# Rezoning Transportation Analysis

Petition Number: 2019-021

## Revision Log:

Date	Description
03-21-19	First Review
06-04-19	Second Review

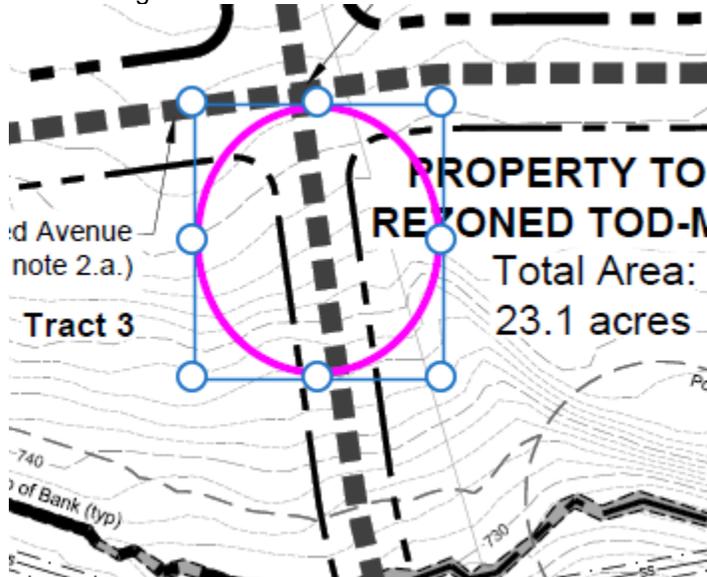
1. **Curbline** The proposed zoning district has a setback measured from back of the existing or proposed future curbline. The location of the future back of curb along North Tryon Street is in it's existing location.

2. **Traffic Study** A Traffic Impact Study is necessary for the complete review of this petition in order to better understand when the round a bout at Sandy Avenue is to be activated and to better determine the lane cross section at the intersection of "connection B" and University City Blvd. In addition, the traffic impact study will help determine the future lane configuration of the proposed fourth leg of the signalized intersection. **Comment Rescinded:** Petitioner worked with CDOT to determine the proper cross section for road.

3. The petitioner should revise conditional note 5.b. to state if Tract 2 is developed first and on it's own then the developer will be required to build all connections shown on site plan in order to maintain multiple points of ingress and egress as they have with the other scenarios under conditional note 5.

4. The petitioner should revise the site plan and conditional note 2.b. to state from connection point B to intersection E the road will be built to a commercial wide cross section. **Comment Rescinded:** Petitioner commits to building street to agreed upon cross section as shown on the site plan.

5. The petitioner should revise the site plan and conditional note 2.b. to state at intersection E on eastern portion of site the road is to have a 3 lane section to accommodate at left turn lane. The road can taper down as it gets closer to creek.

**Additional information:** CDOT is aware that there is a point where the road can be more narrow but would like the petitioner to commit to the 3 lane section at the intersection.

6. The petitioner should revise the site plan and conditional note(s) to better understand the phasing of improvements after whichever tract(s) is developed first. CDOT needs to better understand when the improvements not associated with the tracts being built on their own will be implemented.

7. The petitioner should revise the site plan to add a note specifying dedication and fee simple conveyance of all rights of way to the City before the site's first building certificate of occupancy is issued. CDOT requests right of way set at 2' behind back of sidewalk where feasible.

8. The petitioner should revise the site plan to add a note specifying all transportation improvements will be approved and constructed before the site's first building certificate of occupancy is issued. The petitioner may phase transportation improvements if said improvements and phasing are explicitly described in site plan notes.

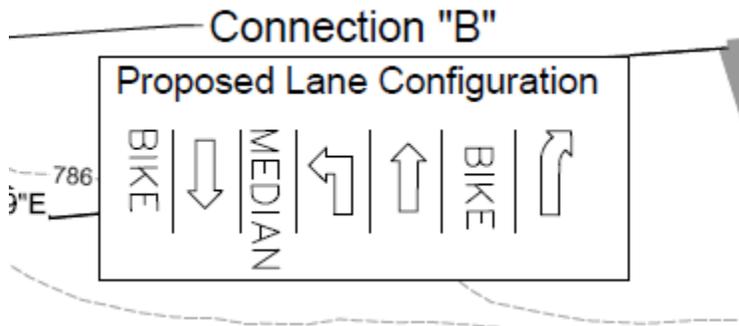
9. **New comment based on site plan 01/28/2019:** Petitioner should add conditional note(s) to commit to the proposed lane configuration shown on site plan.
